ARUP COMMENTS:
 Project No. 256650
 Title: LG Crash Deck - Purcell-EWN-000263
 Date: 16/4/2021
 By: SC

OTH-PUR-XX-XX-RPT-A-0133

Mark up highlighting potential change or "Amber Areas"
 11.06.2021
 Review with Tony Mitchell

Images taken from investigation (Arup) highlighting the complexity of the new design

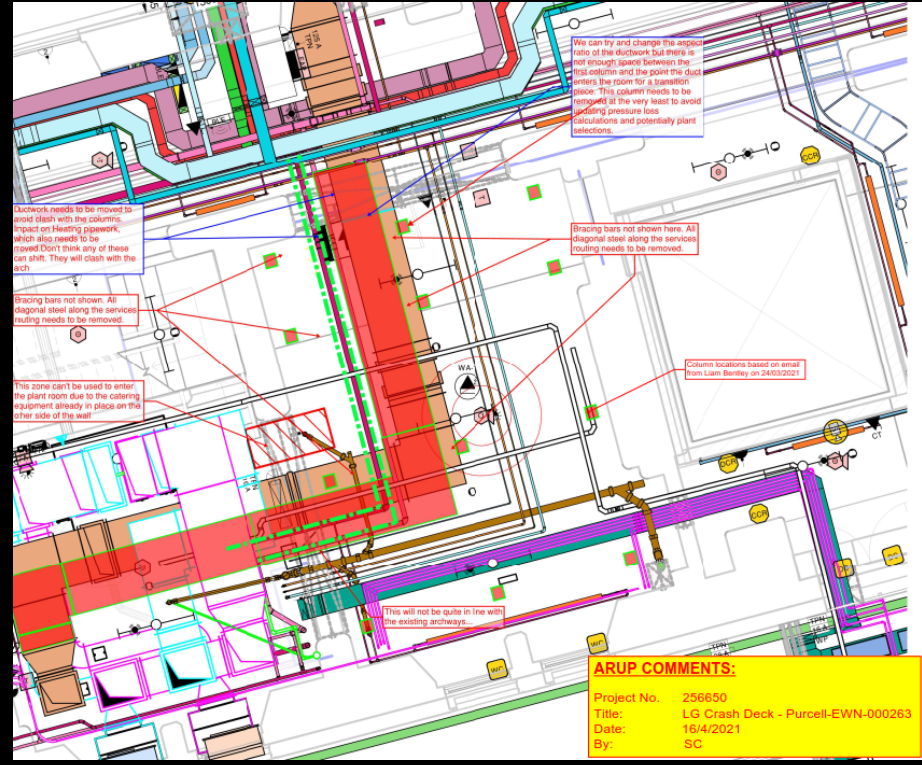
agreed on site walk around 03.03.21 that areas of red are due to riser locations and unable to retain due to services

agreed on site walk around 03.03.21 it would be deemed unethical to reinstate as it would become a bit like "Disney land"

Proposal for area to go to red due to major implications on design re-coordination
